| Issue Date September 30, 2007 |
|-------------------------------------|
| Audit Report Number 2007-SE-1004 |

- FROM: Joan S. Hobbs, Regional Inspector General for Audit, Region X, 0AGA
- SUBJECT: The Tacoma Consortium, Tacoma, Washington, Did not Properly Administer Its HOME Investment Partnerships Program Grants

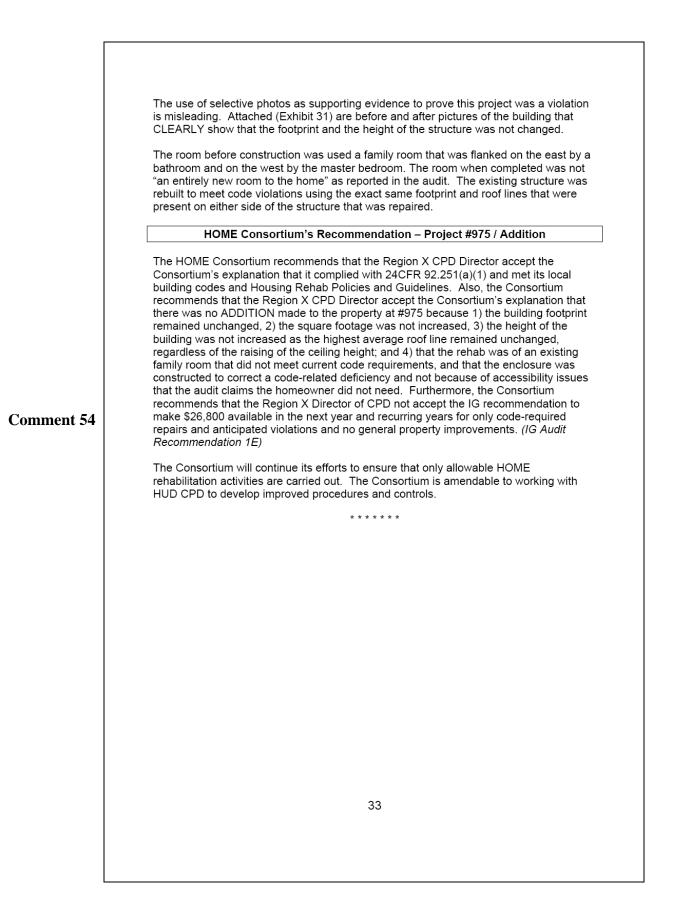
A major addition was made to a home for handicap accessibility for the applicant for project number 1214. According to file documents, there was no immediate need for the home to be handicap accessible. This documentation stated that the applicant "may need some handicap accessibility items" due to arthritic changes in her arms and legs. "This will affect her mobility in the future."

The housing coordinator included a note in the file discussing construction needs. It stated that the current bathroom was "too small to convert to an ADA (Americans with Disabilities Act) approved bathroom." However none of the file documents indicated that the applicant needed an "ADA approved bathroom" since she was not currently in a wheel chair. According to a statement signed by two of her doctors, within the next five to ten years, she would require increasing assistance in performing common household activities. She also "will eventually find herself on a walker, and ultimately a wheelchair." However, the doctors' statements said that as her condition become more severe, she might have to be relocated to an assisted-living facility, rather than staying in the home. Therefore, an addition to the home was not necessary for the applicant at that time. Based on the bid specifications, we estimate that \$44,184 was expended for the addition to the home. (IG Audit Recommendation 1E)

| | limitation of the existing bathroom and the inability to relocate fixtures to meet code requirements, a new bathroom was the best and only solution. |
|--------------------------|--|
| Comment 56 | The existing residence, a two bedroom one bathroom residence and the way the rooms were configured, and the homeowner's need to have the second bedroom for caregivers (family) to stay and care for her, provided a challenge. Thus, the then existing second bedroom was not able to be reconfigured into an ADA bathroom and the appropriate ADA improvements were made to the existing garage accordingly. The conversion of the garage and the access addition provided the owner with a new ADA bathroom complete with a 60° shower unit, ADA toilet and roll under vanity/sink combo, proper ADA clearances between fixtures, and a bedroom directly adjacent the new bathroom allowing the owner immediate access to the ADA bathroom. |
| Comment 57 | Use of selective photos in the IG audit showing the construction of an addition of a deck as part of the rehab work is misleading. This <u>deck was not</u> part of the housing rehab project and was <u>not funded by HOME</u> . Again, the use of selective photos to depict that an addition was made to the home is very misleading. |
